## Planning and Land Use Committee Report

**To:** Planning and Land Use Committee      **Date:** October 2, 2014  
**From:** Helen Cain, Senior Planner, Development Services Division  
**Subject:** Official Community Plan Amendment Application, Rezoning Application #00435 and Development Permit Application #000354 for the property located at 1310 Gladstone Avenue

**RE: 1310 Gladstone Avenue revised proposal for Official Community Plan Amendment, Rezoning and Development Permit Application.**

Survey Plan

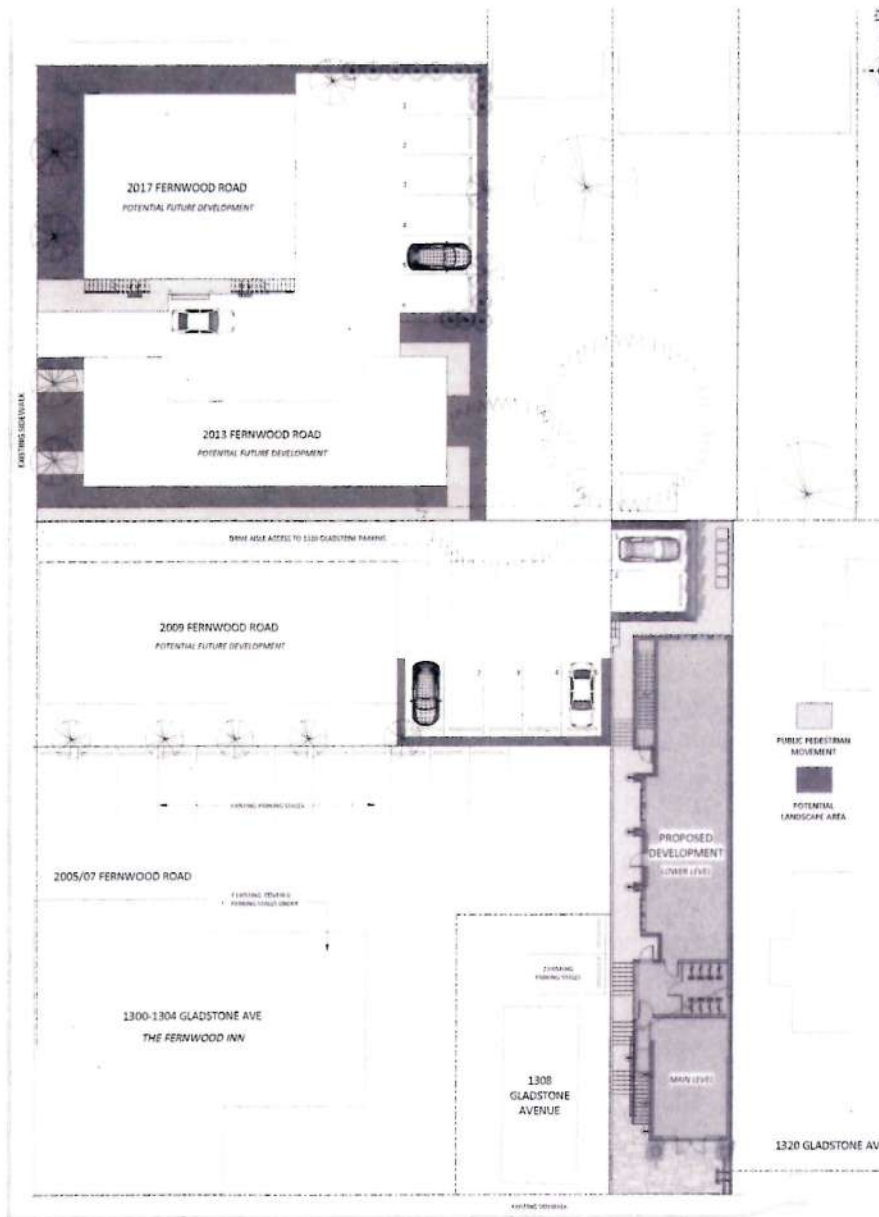
- 2. Update Landscape Plan to include hard surface materials.***

The Site Plan & Landscape Plan on Sheet A0.00 has been updated with annotations identifying the hard surface materials.

Exterior Elevations

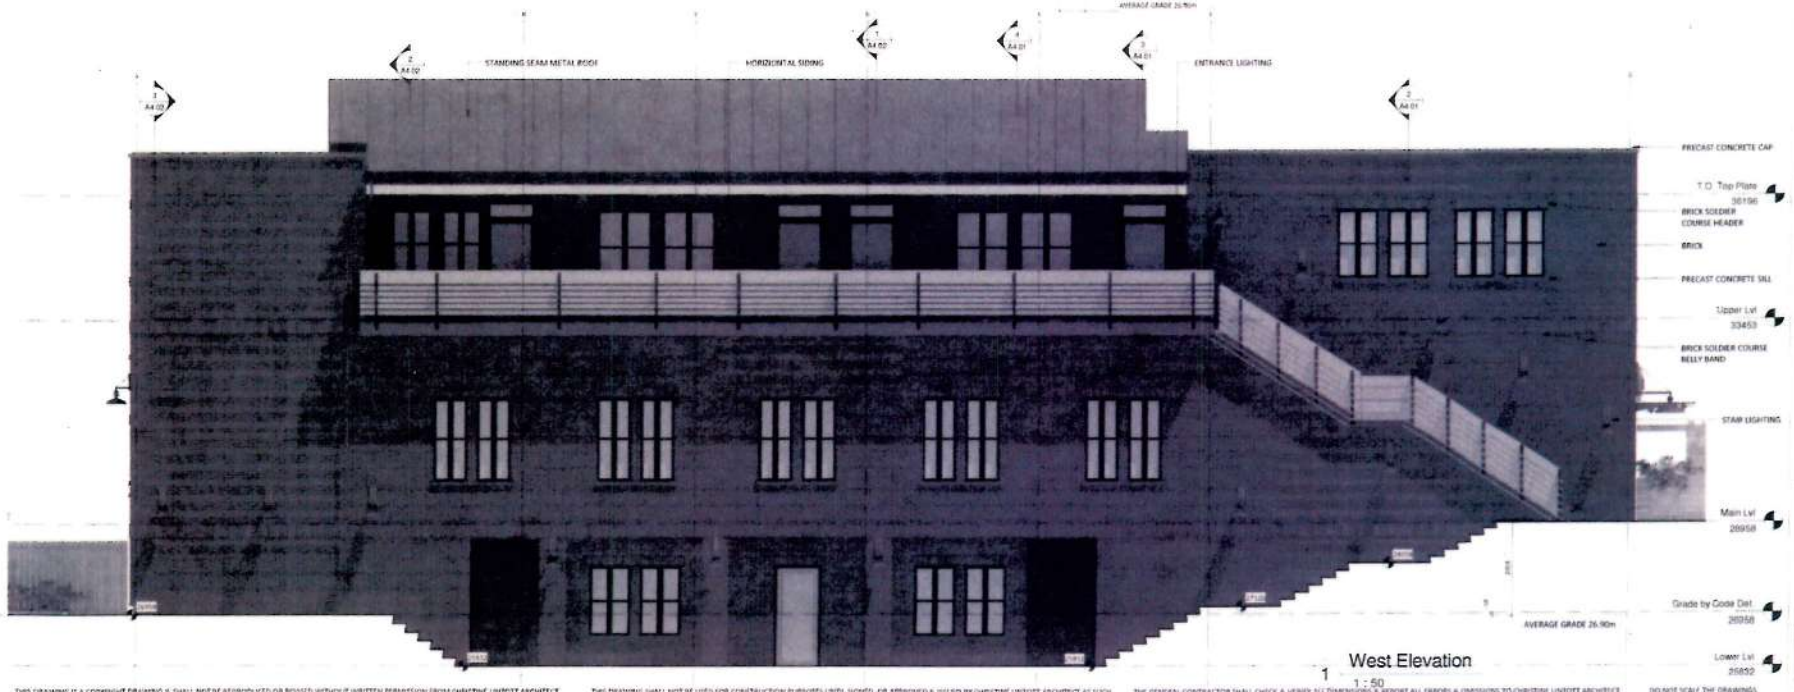
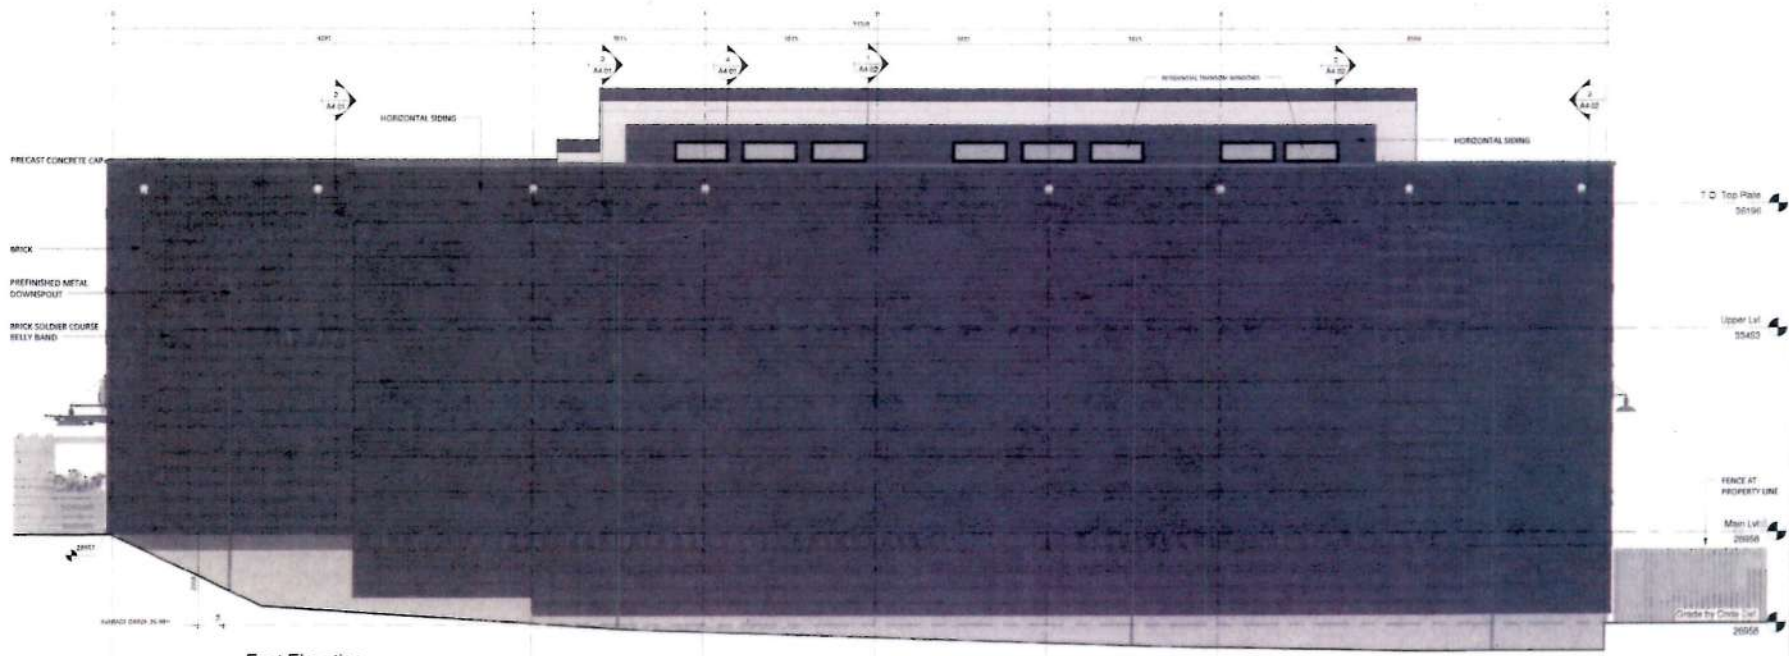
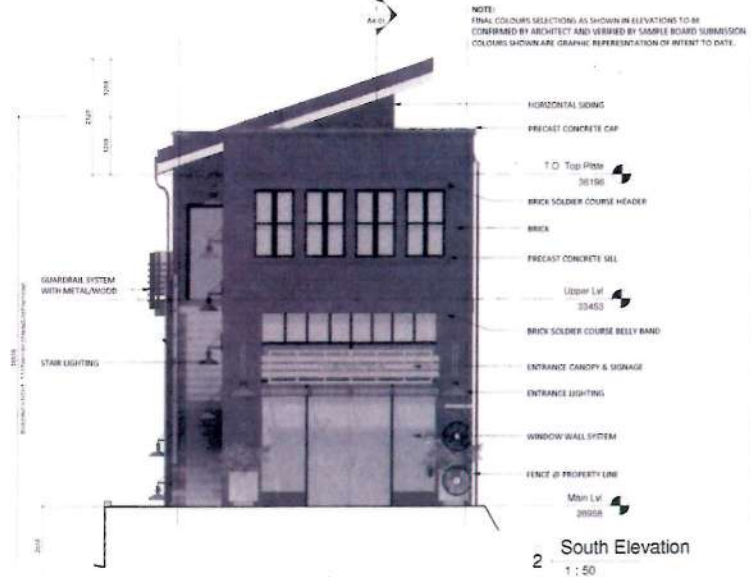
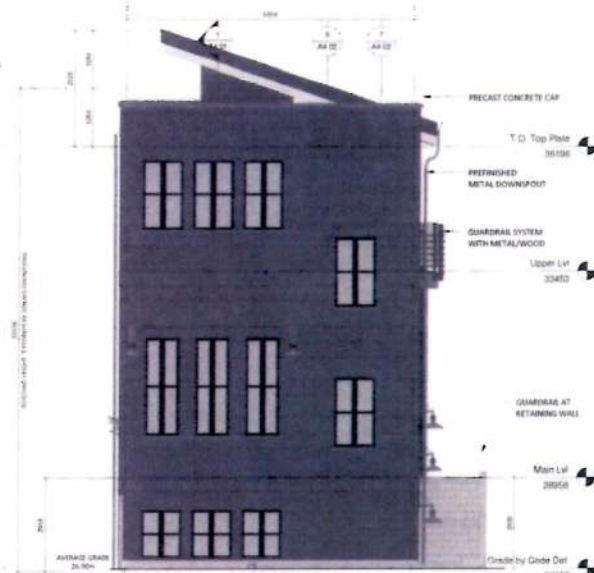
- 3. Please provide at least one colour elevation plan.***

The two primary public elevations on Sheet A3.01 have been resubmitted in colour.
